Safety Recall

N242441390 Seatbelt Retractor May Lock

Release Date: August 2024

Revision: 00

6682024

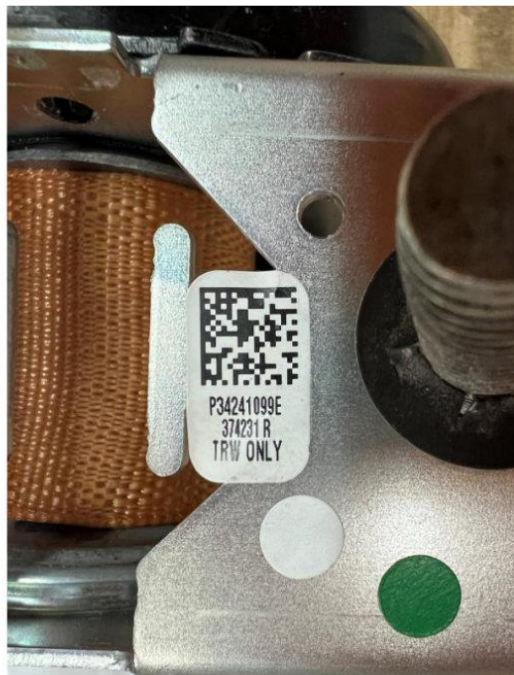
1. Inspect the NEW Seatbelt Retractor labels located on the bottom of the Seatbelt Retractor.
 - If the 4th and 5th digits are "23" AND the 1st and 2nd digits range between "35"- "52", The part is BAD and MUST be scrapped. DO NOT INSTALL ON VEHICLE. Reference the Scrap Instructions below. Re-order a replacement Seatbelt Retractor and repeat inspection.
 - If the 4th and 5th digits are NOT "23" AND the 1st and 2nd digits DO NOT range between "35"- "52" proceed to Step 2.

6682025

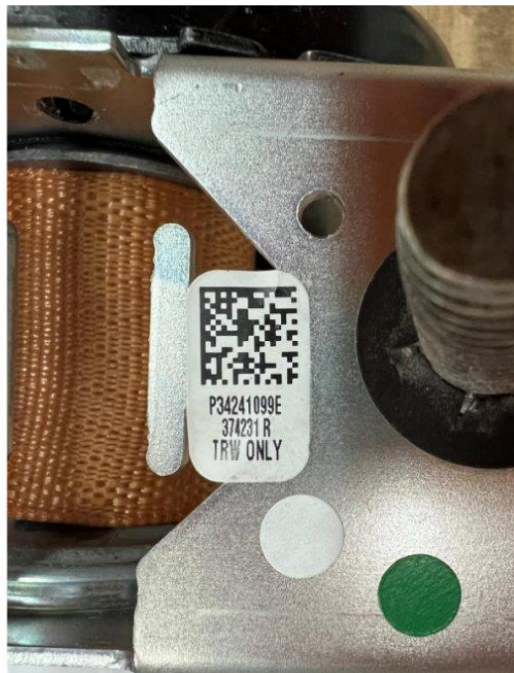
2. Continue to inspect the NEW Seatbelt Retractor labels located on the bottom of them retractor.
 - If the 4th and 5th digits are "24" AND the 1st and 2nd digits are "01", The part is BAD and MUST be scrapped. DO NOT INSTALL ON VEHICLE. Reference the Scrap Instructions below. Re-order a replacement Seatbelt Retractor and repeat inspection.
 - If the 4th and 5th digits are NOT "24" AND the 1st and 2nd digits are NOT "01" proceed to Step 3.
3. Replace BOTH the LH and RH Front Seat Belt Retractor. Refer to *Front Seat Belt Retractor Replacement* in SI. If convertible, refer to *Front Seat Belt Retractor Replacement - Right Side (Convertible)* and *Front Seat Belt Retractor Replacement - Left Side (Convertible)* in SI.
4. Scrap all replacement Seat Belt Retractors that failed inspection steps 1 and/or 2 AND the used Seatbelt Retractors. Refer to the Scrap instructions below.
